# **WESTBROOK COMMUNITIES**

**What We Heard Report - Phase 3: REFINE  
October 5, 2022**

# Westbrook Communities Local Growth Planning Project

## Phase Three: REFINE Engagement & Communications Summary

**Question: Did we get the Draft Urban Form Map right? If no, what additional changes should be considered, and why?**

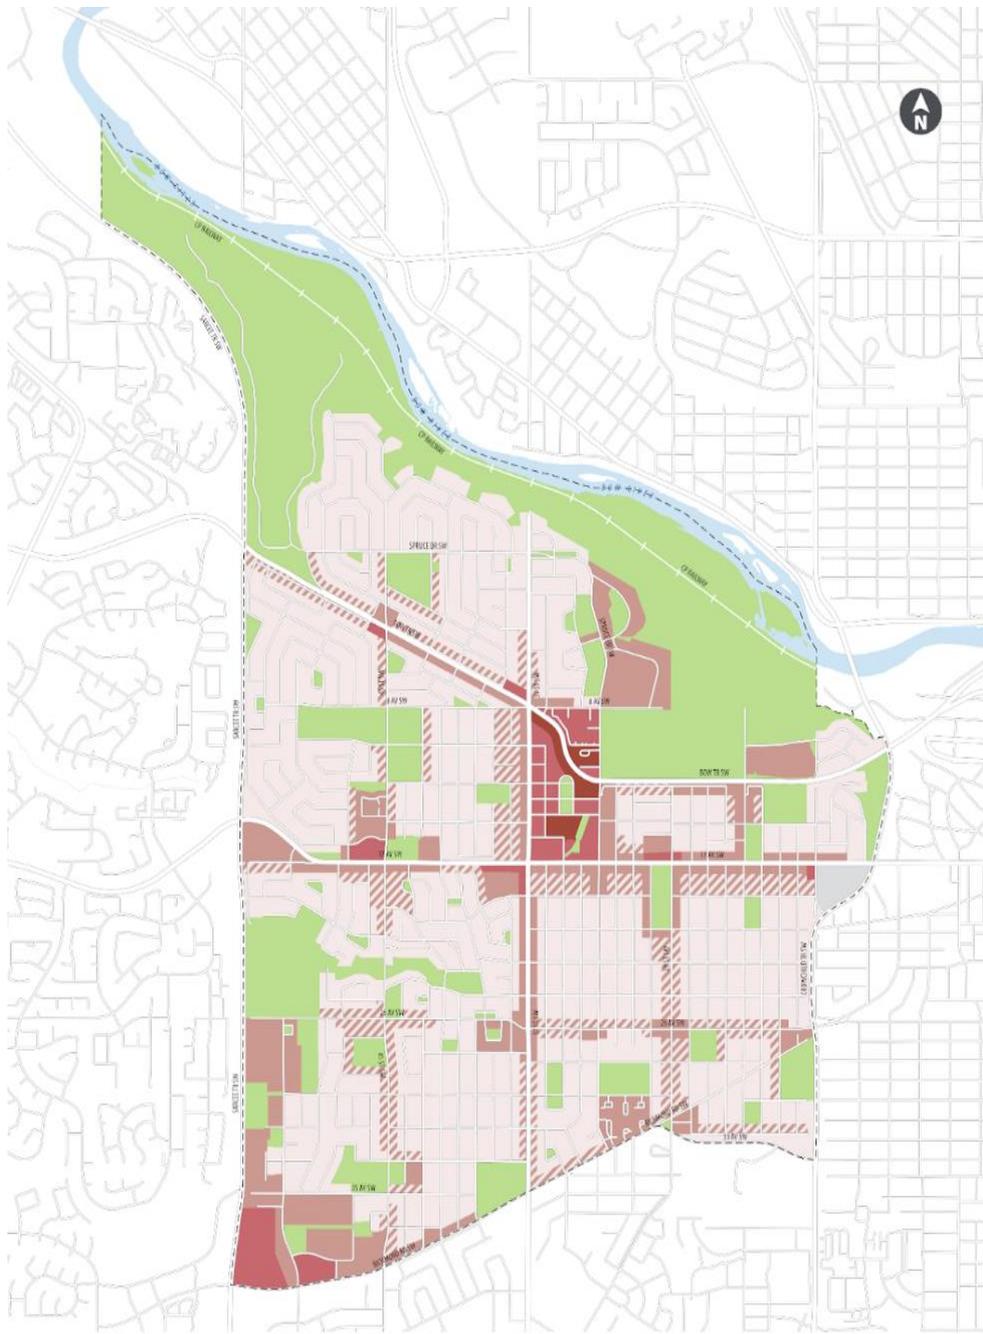
- Bow Trail between 33rd and 37th might be better as neighborhood commercial similar to the building scale map.
- The portion of 45 ST SW between Turtle Park and the 45 ST SW LRT station has potential to become a quirky small scale shopping strip with coffee shops, restaurants, galleries, local shops, etc.
- Removing yellow shading for 45 St north of Spruce Drive on the Urban Form Map. This will confuse community on what the perception will be allowed in this area, especially when comparing it to the Building Scale Map.
- Having a policy on smaller lot subdivision in place would be helpful, rather than relying on the rules of RC2.

**1. Map 1: Draft Urban Form Map - we recommend developing a “neighborhood commercial” along 17th Ave (Main Street) and changing 25, 25A, 26A and 26 street (South of Bow Trail) from neighborhood connector / Flex to neighborhood local.**

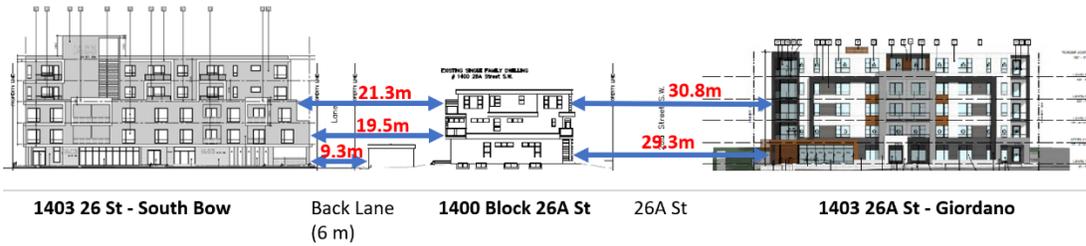
The purpose of Shaganappi Point LRT Station is to commute people to work, and foot traffic is observed between 7-8:30am. There are safety concerns with increasing traffic and loading zones nearby the elementary school (Alex Ferguson) on 26 Street. In addition, the existing street parking as well as front or back commercial loading zone requirements are not viable given narrow road width in 26 street and the narrow back lane shared between 25, 25A, 26 and 26A. This issue has been confirmed through the past development applications engagement and Subdivision Development Appeal Board Hearings.
